Document Type:	Detail Design Review
To:	Alana Travis, APP
From:	John Piechowski, Indesco
Date:	Wednesday, 7 October 2020
Project Number:	7391
Project Name:	Queanbeyan Civic & Cultural Precinct
SUBJECT:	ON SITE DETENTION TANK REVIEW

Figure 1: Aerial Imagery of Existing Development (ACTmapi, 2018)

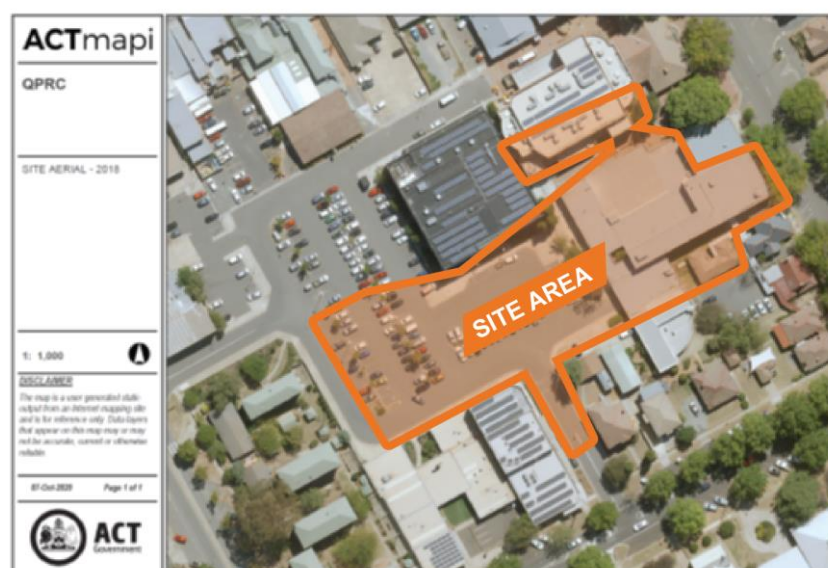
Per Figure 1 the existing development consisted of predominantly impervious area. The impervious area was calculated to be approximately 95%. Per Figure 2 the proposed development increases the pervious area by approximately 1,000m² by providing a central landscaped area. The impervious area was calculated to be approximately 85%.
